Access Compliance Report Public Rights-of-Way (Curb Ramps)

Main Street: YELLOWSTONE_DR Cross Street: RUSHMORE_LN Location: NE

ADA ID: RPAT211007150348 Ramp Type: Type 1 - Perpendicular Diagonal Initial Pass/Fail: Fail Overall Compliance: No Severity Score: 2

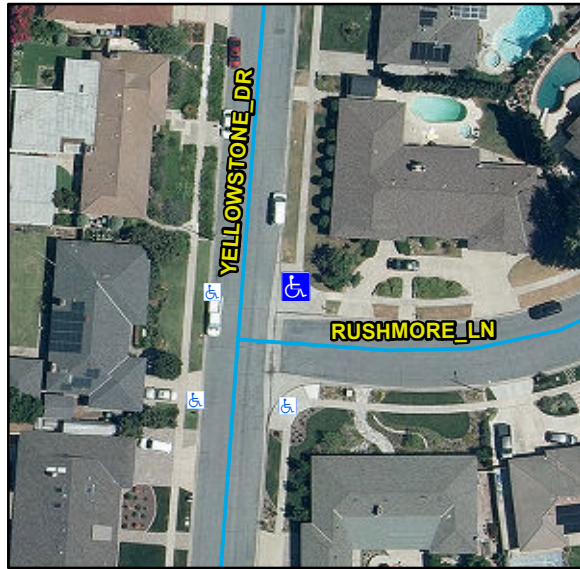
Compliance	Description	Data	Compliance	Description	Data
N/A	Ramp Length (in)	128	N/A	Flare Type LT	
Yes	Ramp Width (in)	61			N/A
Yes	Ramp Run Slope (%)	5.9	N/A	Flare Slope LT (%)	N/A
No	Ramp Cross Slope (%)	3.2	N/A	Flare Traversable LT	N/A
N/A	Landing Present	N/A	N/A	Flare Type RT	
N/A	Landing Length (in)	N/A			N/A
N/A	Landing Width (in)	N/A	N/A	Flare Slope RT (%)	N/A
N/A	Landing Run Slope (%)	N/A	N/A	Flare Traversable RT	N/A
N/A	Landing Cross Slope (%)	N/A	N/A	DWS Provided	N/A
N/A	Landing Movement Obstructed?	N/A	N/A	DWS Contrast	N/A
	Landing Movement Type	N/A	N/A	DWS Length (in)	N/A
N/A	Landing Shared	N/A	N/A	DWS Full Width	N/A
N/A	Clear Space	Yes	N/A	DWS Offset Left (in)	N/A
N/A	Clear Space To Crosswalk (in)	N/A	N/A	DWS Offset Right (in)	N/A
N/A	Marked Crosswalk 1	No	N/A	Marked Crosswalk 2	No
	Crossing 1 Direction	W		Crossing 2 Direction	S
	Marked Crosswalk 1 Width (in)	N/A		Marked Crosswalk 2 Width (in)	N/A

Remove & Replace Curb Ramp With Two New Directional Ramps or Equivalent.

R304.5.3, STD 1115
